AURA 8014 VANTAGE

JOB 25013- DEVELOPMENT APPROVAL

PLANS AND DOCUMENTS
referred to in the PDA
DEVELOPMENT APPROVAL

Approval no: DEV2025/1640

AURA -8014 - BUILDING A - ELEVATIONS

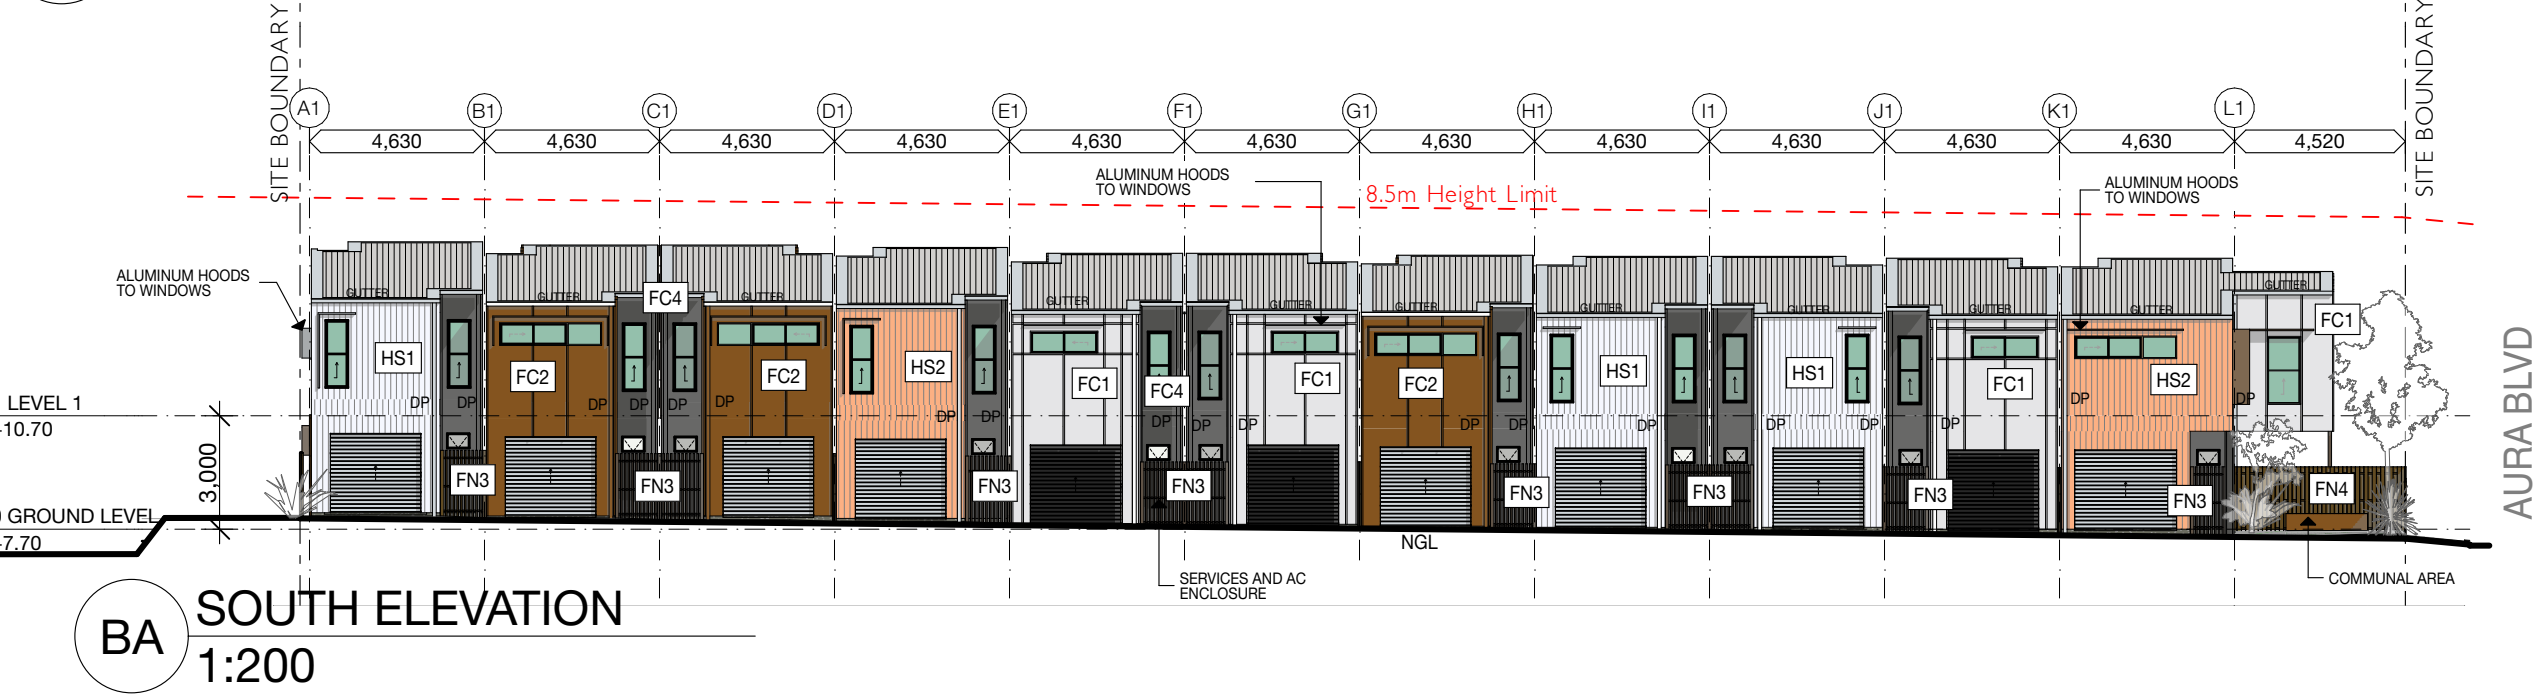
Front fencing must be at least 50% transparent where greater than 1.2m in height

AURA -8014 - BUILDING B - ELEVATIONS

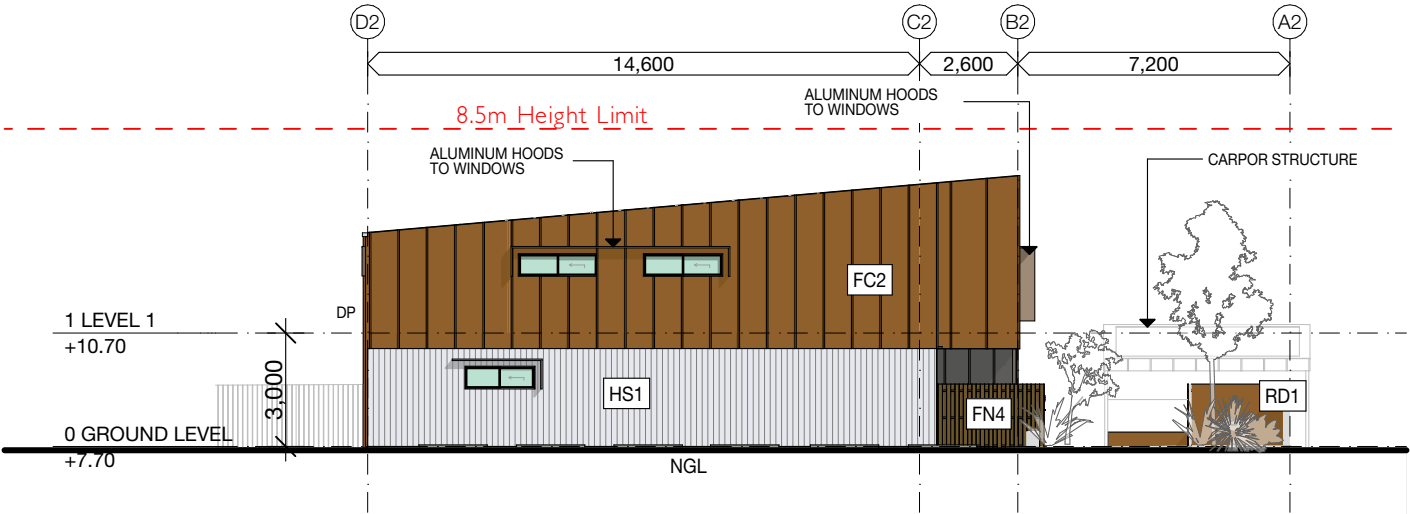
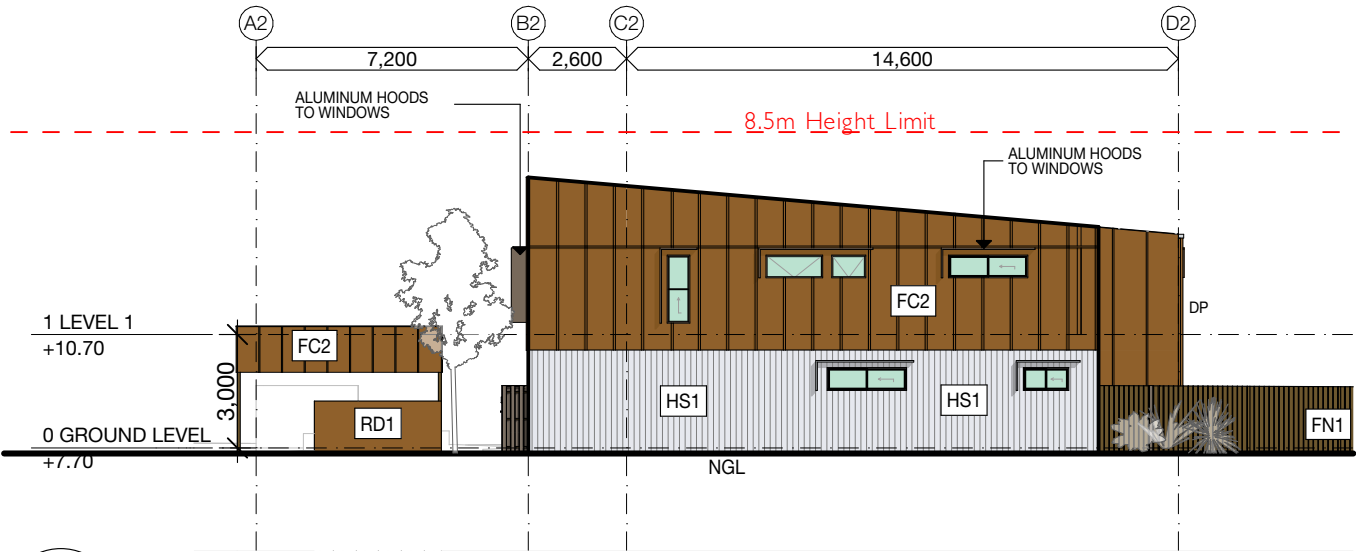
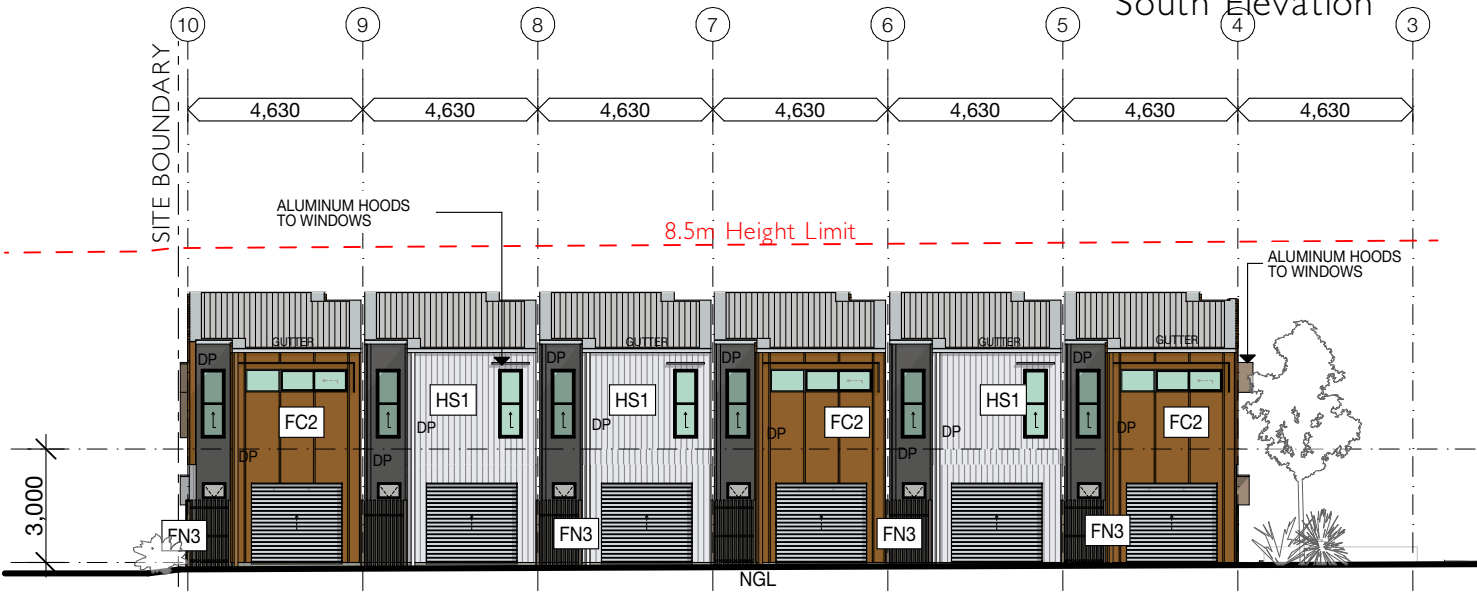
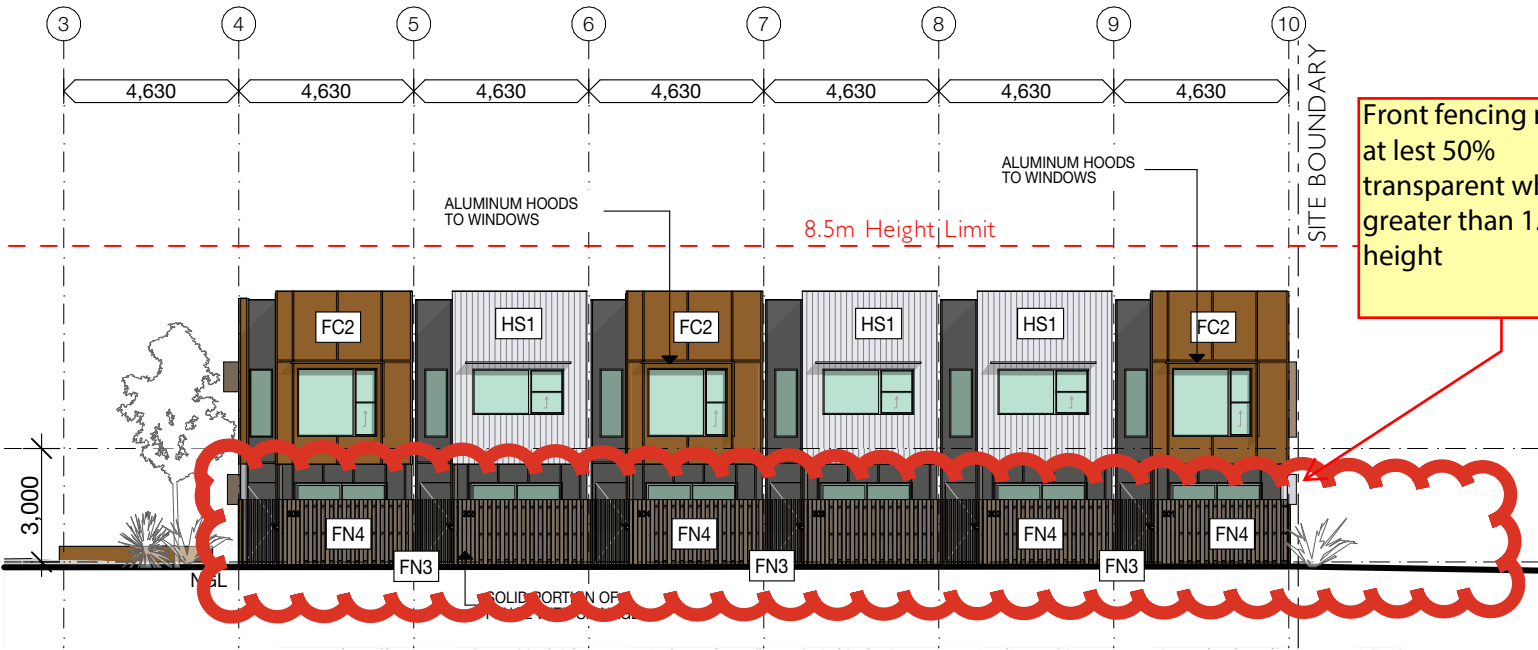
Front fencing must be at least 50% transparent where greater than 1.2m in height

AURA -8014 - BUILDING C - ELEVATIONS

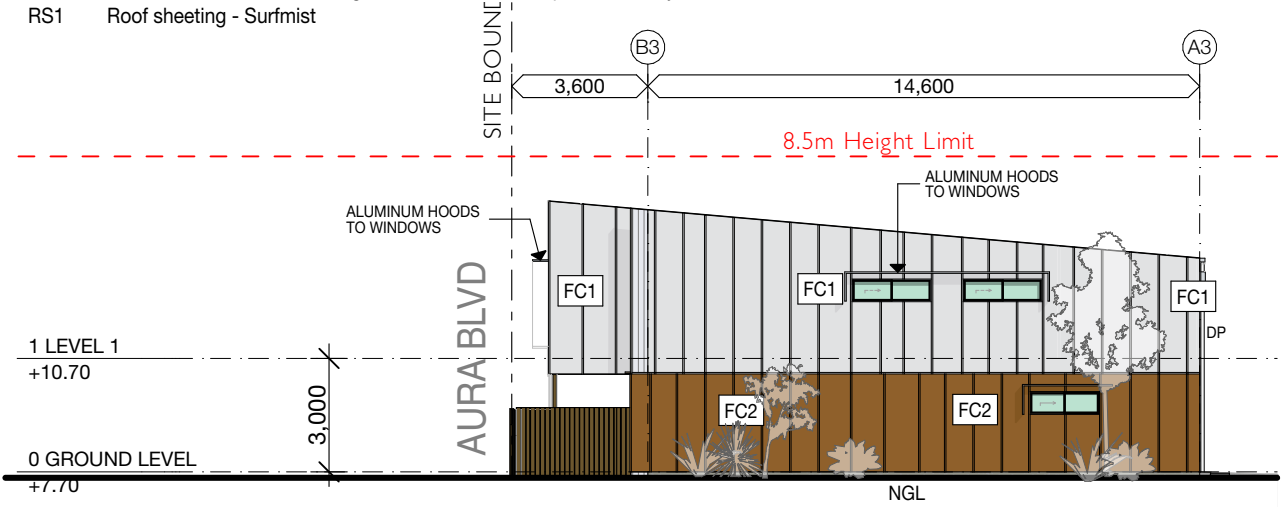
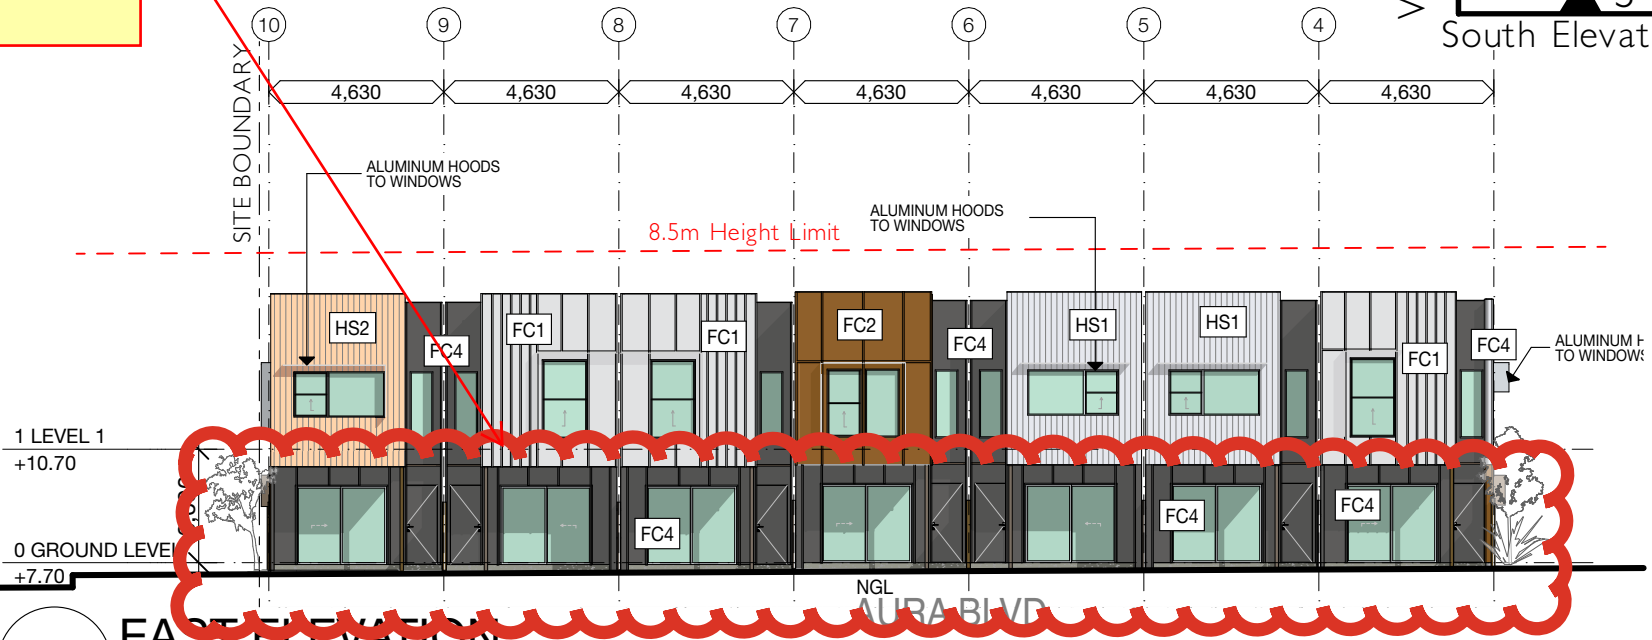
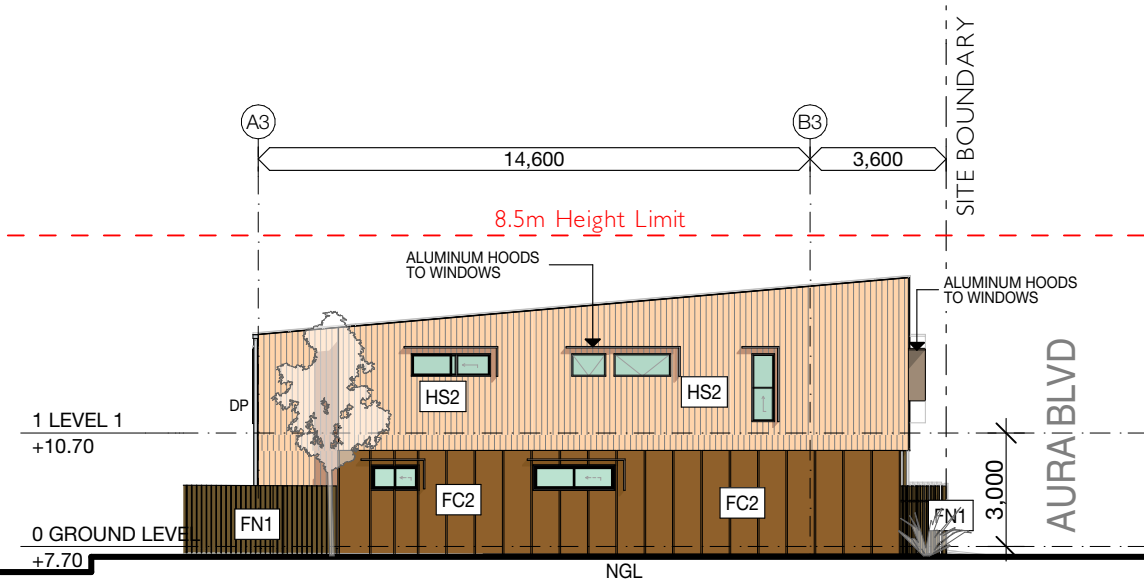
Front fencing must be at least 50% transparent where greater than 1.2m in height
